# **Independent Peer Review Panel**

## **Evaluation of Proposed Seismic Hazard Studies at Diablo Canyon and San Onofre**

**IPRP Report No. 5 *March 25, 2013***

**Slip Rate of the Hosgri Fault: summary of available data  
and comments on ongoing investigations by PG&E for  
Diablo Canyon Power Plant seismic hazard studies**

**2010-2011 3D High-Resolution Survey Areas**

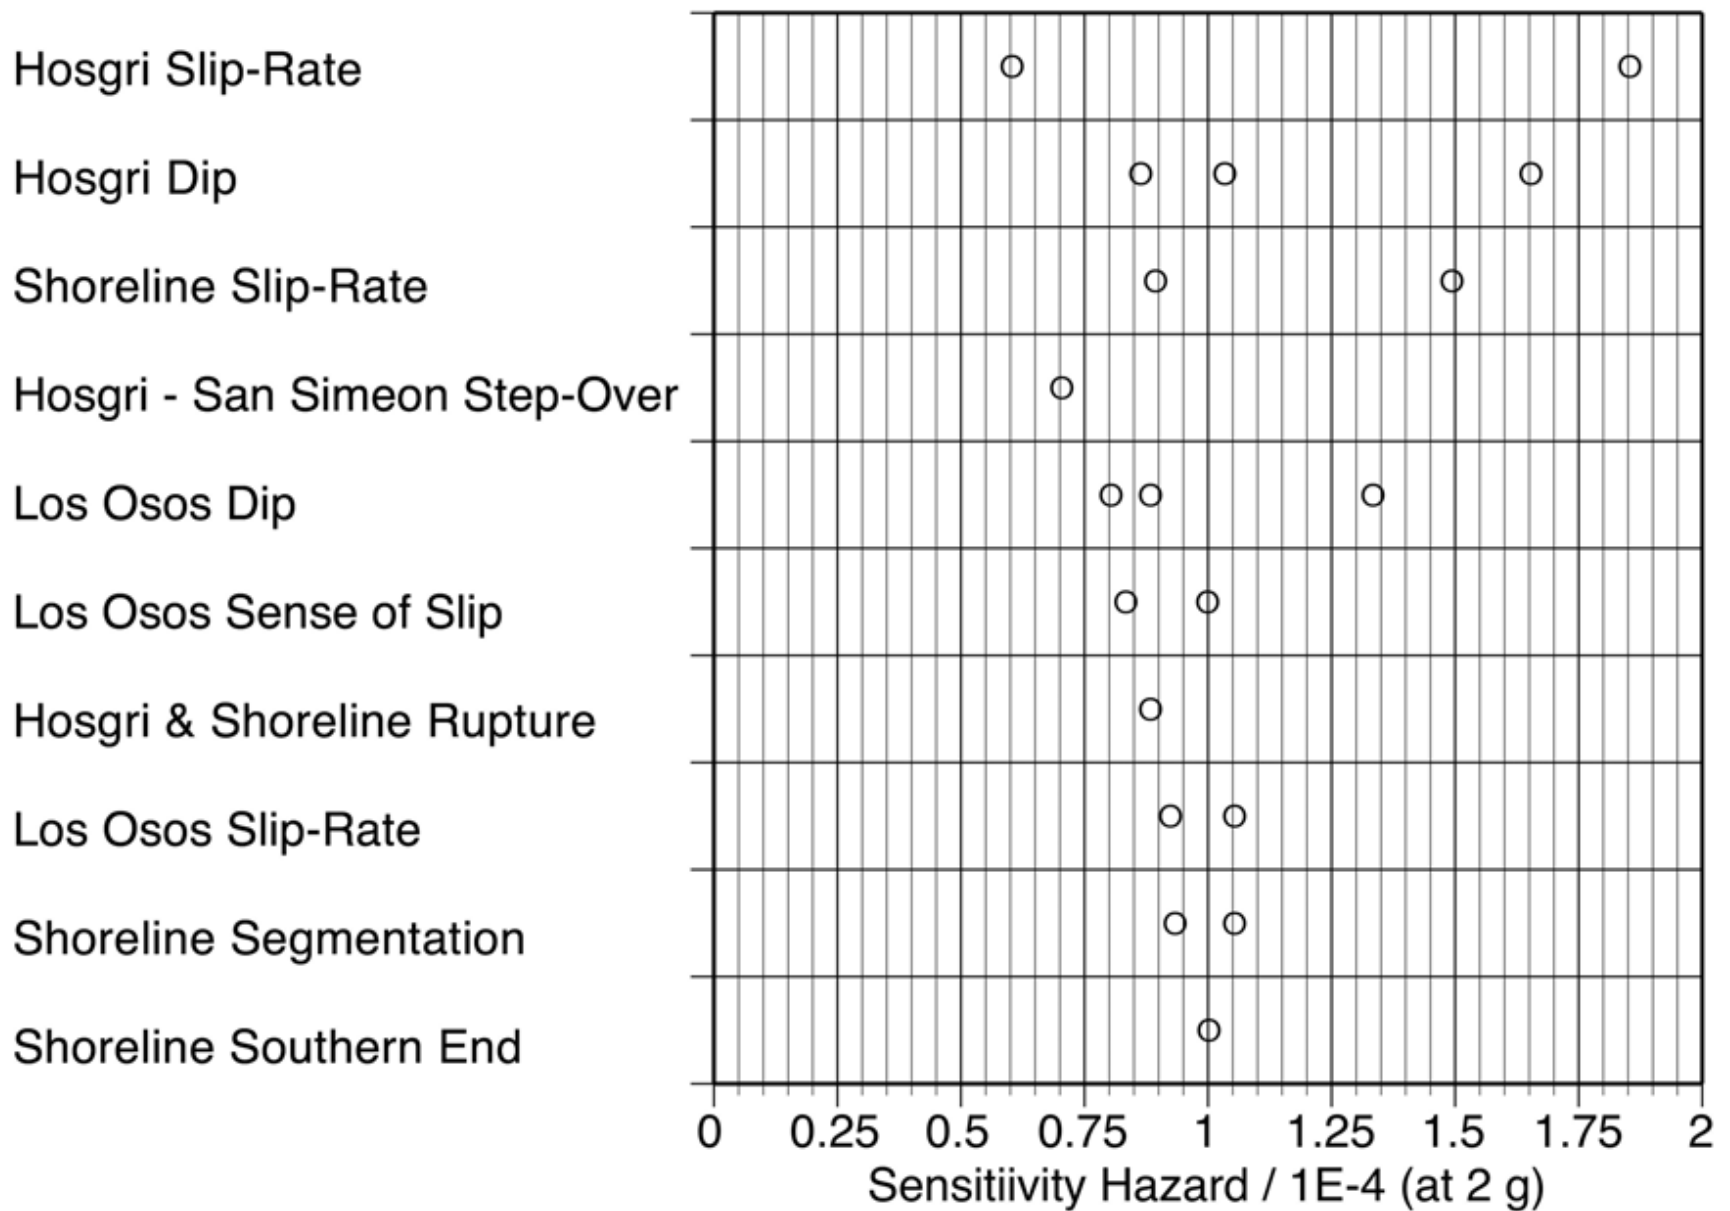
<b>Object of study</b>	<b>PG&amp;E Study Plans</b>	<b>IPRP Evaluation of PG&amp;E Study Plans</b>	<b>Priority/Status</b>
<b>Hosgri Fault Slip Rate</b>	Low Energy 3-D Seismic Survey	The IPRP recommends further studies to decrease the uncertainty in the seismic hazard at Diablo Canyon by better constraining the slip rate on the Hosgri Fault.	High/ Recommended
<b>Shoreline Fault Slip Rate</b>	Low Energy 3-D Seismic Survey	The IPRP recommends further studies to decrease the uncertainty in the seismic hazard at Diablo Canyon by better constraining the slip rate on the Shoreline Fault.	High/ More Recommended
<b>Southeast End of Shoreline Fault</b>	Low Energy 3-D Seismic Survey	This type of study has as good a chance as currently feasible of providing data on the orientation and continuity of the southeast end of the Shoreline Fault. The IPRP recommends that a secondary focus of these studies should be to constrain any potential connections to faults on-shore.	Moderate/ More Recommended

# 3D Block Diagram SW Point Buchon

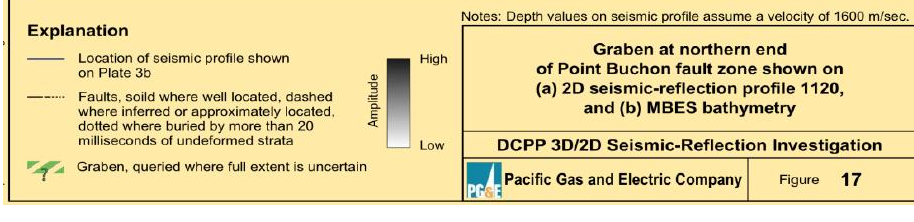
Object of study	PG&E Study Plans	IPRP Evaluation of PG&E Study Plans	Priority/Status
<b>Los Osos Fault Dip</b>	High Energy on-land 2-D Seismic Survey	The current plans for on-land seismic surveys appear to be adequate to image reverse faults beneath the hills. The IPRP will be interested in reviewing the results that show the Los Osos Fault, but also any other geologic structure or structures beneath the hills.	High/ Awaiting results of surveys in 2011
<b>Los Osos Sense of Slip</b>  <b>Los Osos Slip Rate</b>	High Energy on-land 2-D Seismic Survey	The IPRP believes that a broader goal of the on-land seismic surveys should be for PG&E to develop a tectonic model of the Irish Hills that includes defining the locations and slip rates on all faults beneath the hills that can be checked against rates of uplift and surface deformation.	High/ Awaiting results of surveys in 2011

# 2011 Vibroseis and Node Coverage

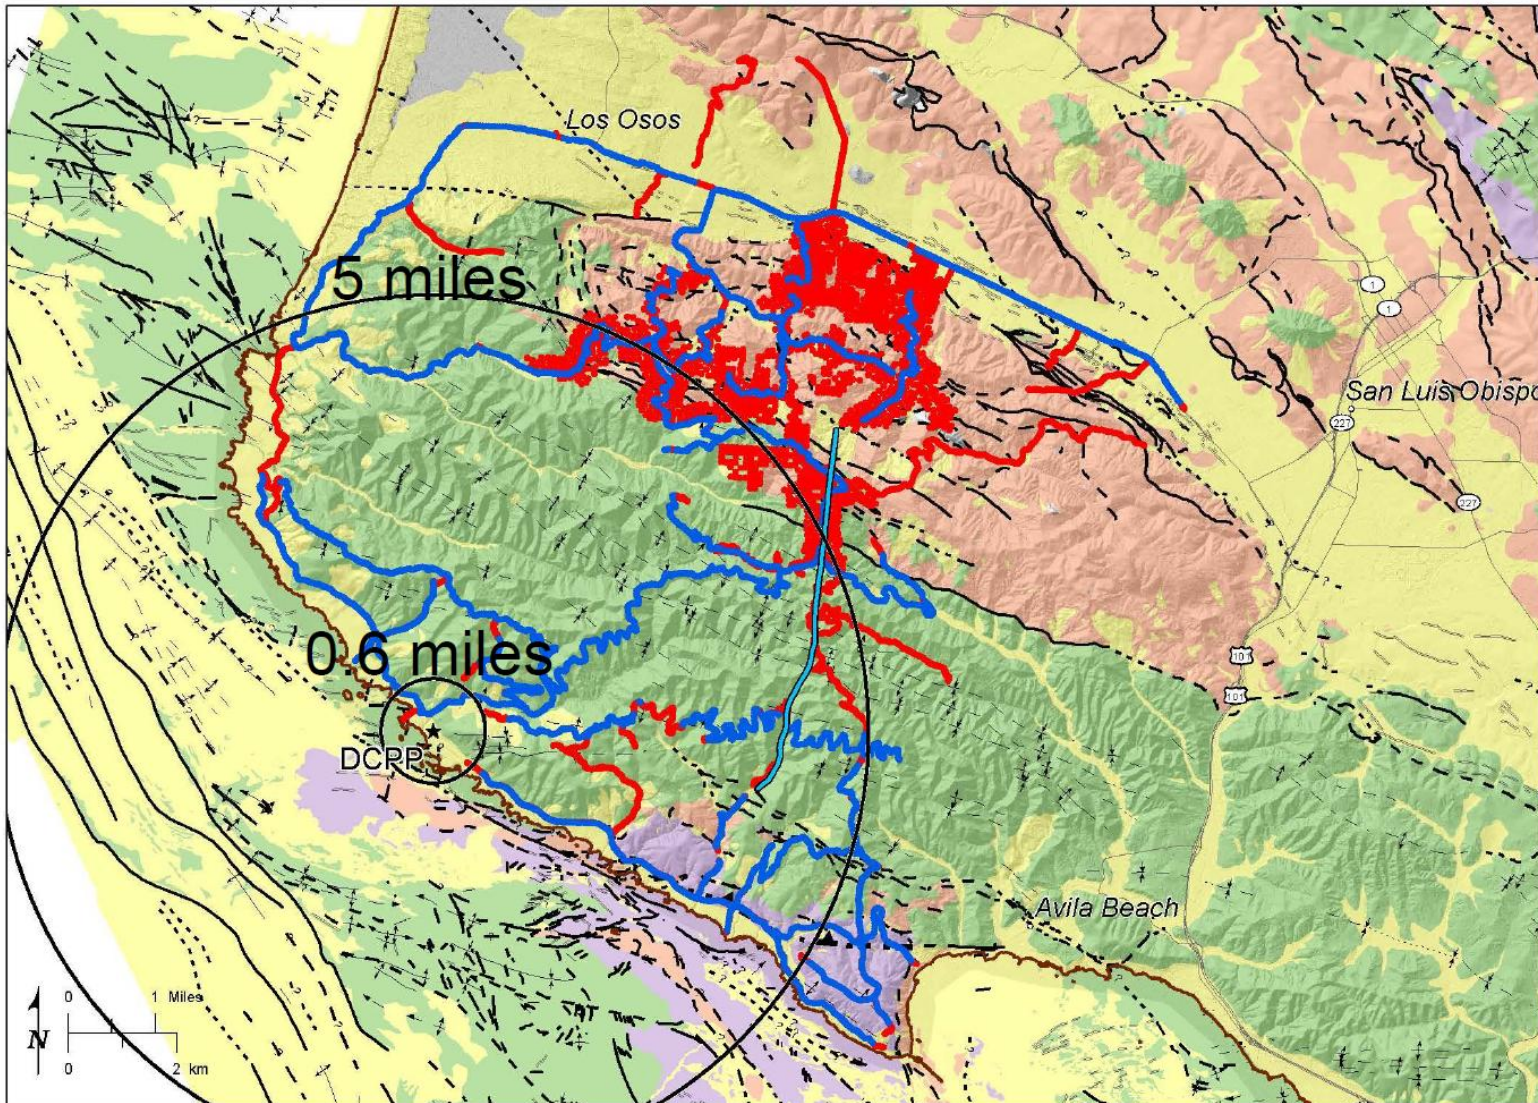
<b>Object of study</b>	<b>PG&amp;E Study Plans</b>	<b>IPRP Evaluation of PG&amp;E Study Plans</b>	<b>Priority/Status</b>
<b>Hosgri-Shoreline Intersection</b>	High Energy 3-D Seismic Survey	This type of study has as good a chance as currently feasible of providing data on the intersection of the Hosgri and Shoreline Faults.	Moderate/ CCC permit denied
<b>Hosgri Dip</b>	High Energy 3-D Seismic Survey	This type of study has as good a chance as currently feasible of providing data on the dip the Hosgri Fault near the intersection of the Shoreline and the Hosgri Faults.	Moderate/ CCC permit denied
<b>Shoreline Fault Segments</b>	High Energy 3-D Seismic Survey	This type of study has as good a chance as currently feasible of providing data on the orientation and continuity of the Shoreline Fault at depth	Moderate/ CCC permit denied
<b>Hosgri-San Simeon Step-Over</b>	High Energy 3-D Seismic Survey	Ongoing investigation and more closely spaced seismic survey lines by USGS have shown that the direct connection between the San Simeon and Hosgri Faults is by far the most likely explanation from the available data. It appears very unlikely that additional data from high energy survey of this area would significantly change the seismic hazard analysis results based on these faults.	Low/ No Longer being considered
